REMARKS

In response to the Final Office Action mailed October 7, 2005, Applicants respectfully request reconsideration. To further prosecution of this application, each of the issues raised in the Final Office Action is addressed herein.

PATENTS
Serial No.: 10/664,415
Confirmation No.: 3198
Attorney Docket No. CKB-079.02

FIG. 1

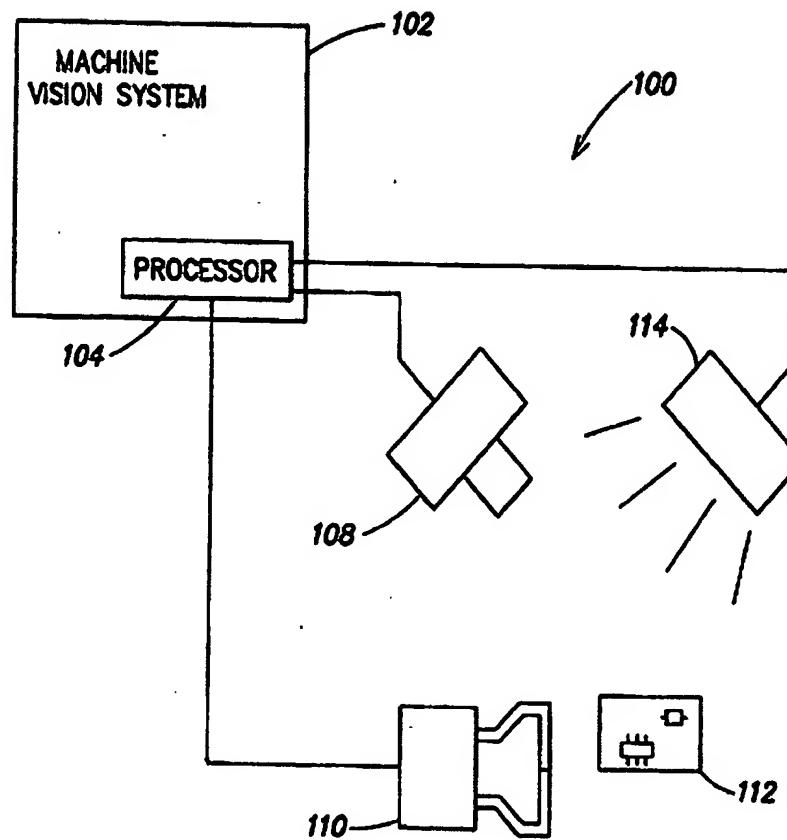
Please amend Figures 1, 2, and 3 and add Figure 4 as indicated in red on the attached annotated sheets. Clean replacement copies of all figures are also included on the attached replacement sheets.

FIG. 4

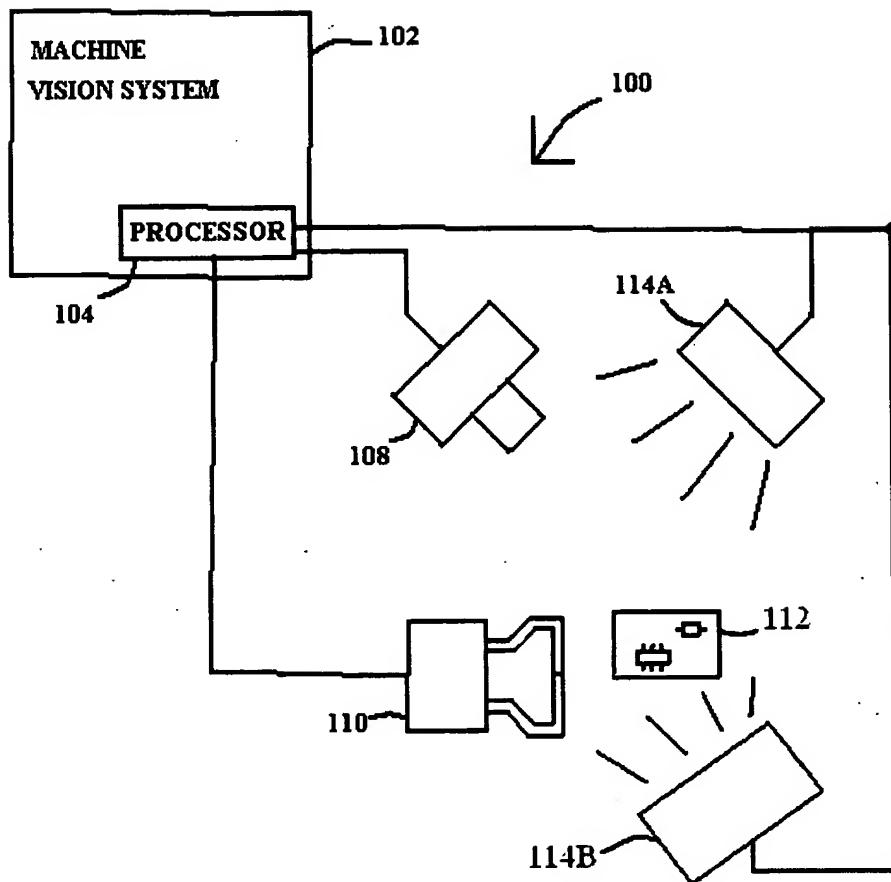
In stark contrast, at least one embodiment of Applicants' invention allows for an addressable lighting system to share a communication medium with another device (e.g., another addressable lighting system), as shown in Applicants' Figure 4. Figure 4 shows two lighting systems, 114A and 114B attached to the processor 104 by one communication medium. At least one of these lighting systems is capable of distinguishing control signals sent via this medium that are meant to control it from control signals sent via this medium

that are not meant to control it (and may be meant to control the other lighting system or some other device).
